ADDENDUM TO
SPECIFICATIONS ENTITLED
"SPECIFICATIONS FOR 514 MAIN STREET
ROOF REPLACEMENT
UNIVERSITY OF SOUTH CAROLINA
COLUMBIA, SOUTH CAROLINA
PROJECT NO. H27-6100A CP00336848/FM00385442"

ADDENDUM NO. 1

SEPTEMBER 19, 2013

SHEET NUMBER:
R-100

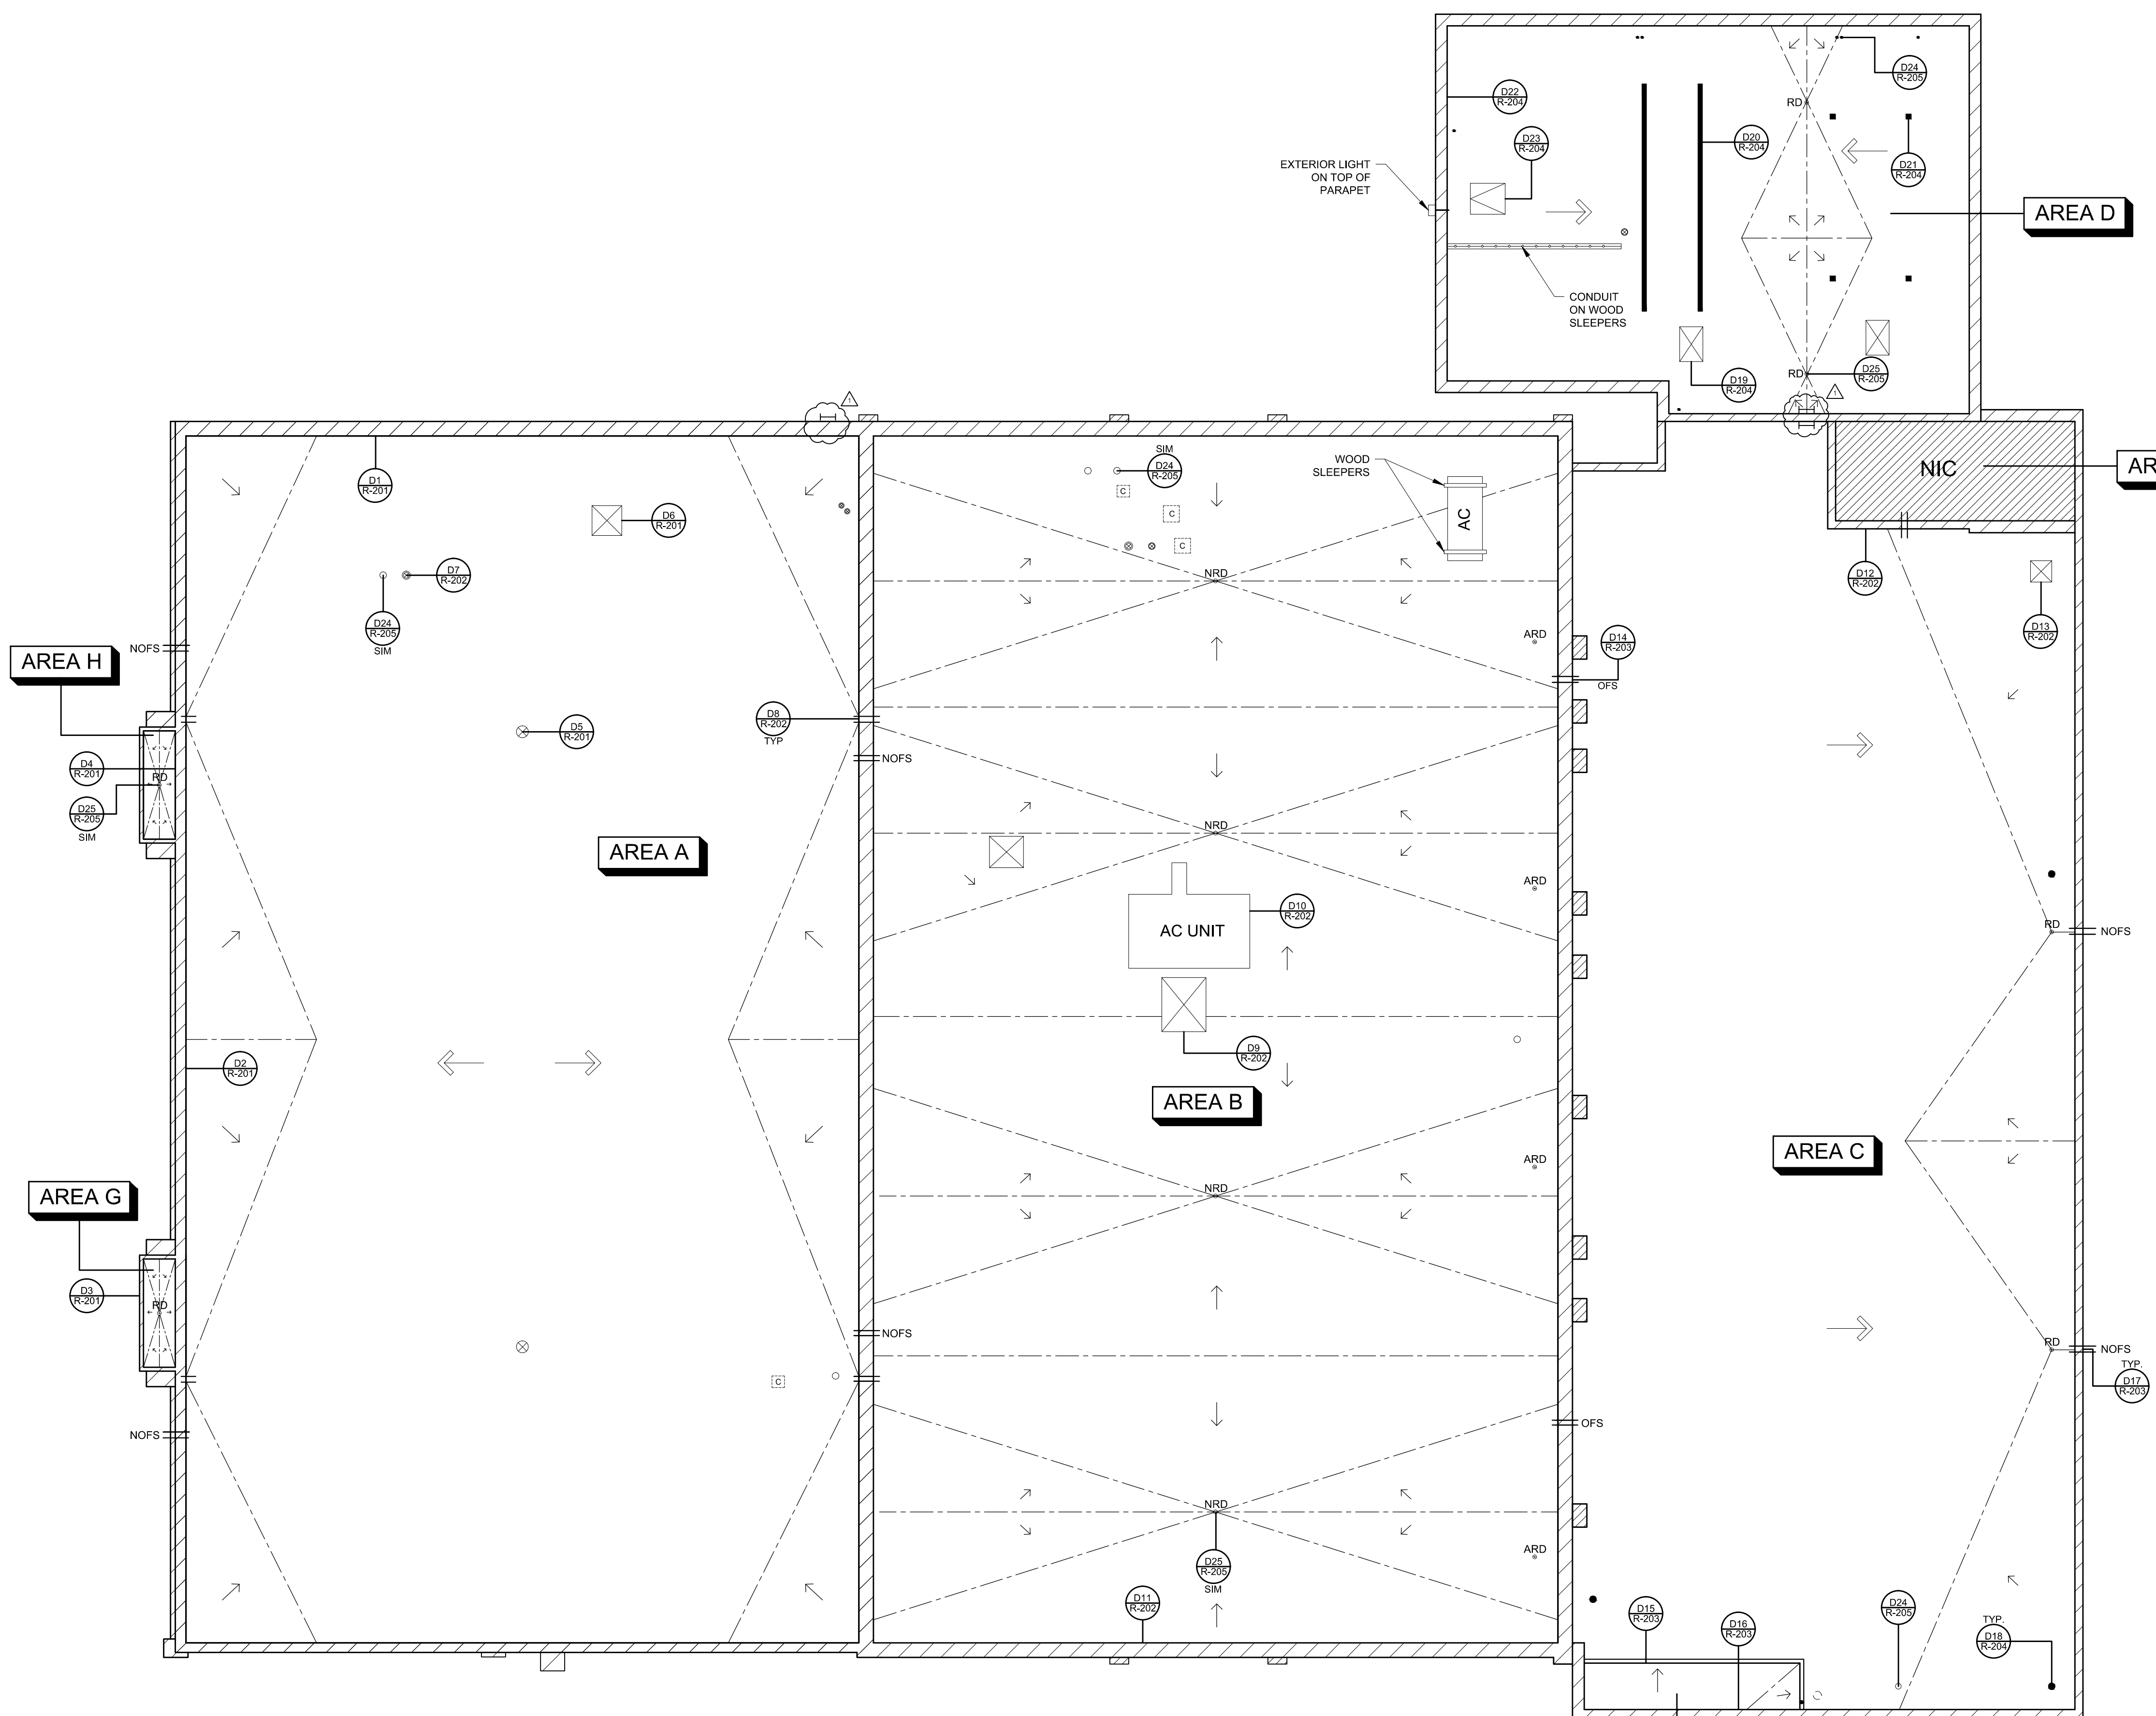
9. Delete Roof Plan R-100 and replace with the attached Roof Plan R-100 (Addendum No. 1).
